Access Compliance Report

Public Rights-of-Way

Intersection ID: 44073	Main Street: WESTMILL_LN	Cross Street: SEDGEMOOR_LN	Location:	N
ADA ID: AC7894F98228	Ramp Type: PerpDiag	Initial Pass/Fail: Fail	Overall Compliance: No	Severity Score: 47.5

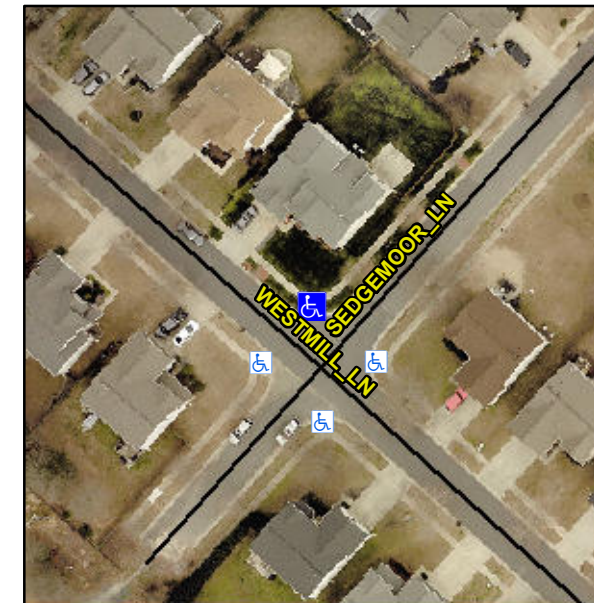
R304.5.1, R304.5.3

Compliance	Description	Data	Compliance	Description	Data
N/A	Ramp Length (in)	73.0	Yes	Ramp Slope (%)	5.0
No	Ramp Width (in)	27.5	No	Ramp XSlope (%)	5.1
N/A	Flare Type LT	N/A	N/A	Flare Type RT	N/A
N/A	Flare Slope LT (%)	N/A	N/A	Flare Slope RT (%)	N/A
N/A	Flare Traversable LT?	N/A	N/A	Flare Traversable RT?	N/A
N/A	Landing Length (in)	N/A	N/A	DWS Provided?	N/A
N/A	Landing Width (in)	N/A	N/A	DWS Contrast?	N/A
N/A	Landing Slope (%)	N/A	N/A	DWS Length (in)	N/A
N/A	Landing X Slope (%)	N/A	N/A	DWS Full Width?	N/A
N/A	Landing Curb? (Y/N)	N/A	N/A	DWS Offset (in)	N/A
N/A	Shared Landing?	N/A			
N/A	Gutter Ponding?	N/A	N/A	Gutter Slope (%)	N/A
N/A	Gutter Lip Ht (in)	N/A	N/A	Gutter X Slope (%)	N/A
N/A	Painted X Walk1?	No	N/A	Painted X Walk2?	No
	X Walk 1 Direction	To SW		X Walk 2 Direction	To SE
N/A	X Walk 1 Width (in)	N/A	N/A	X Walk 2 Width (in)	N/A
	X Walk 1 Slope (%)	4.7		X Walk 2 Slope (%)	0.8
	X Walk 1 X Slope (%)	2.0		X Walk 2 X Slope (%)	3.9

Remove & Replace Curb Ramp With Two New Directional Ramps or Equivalent.
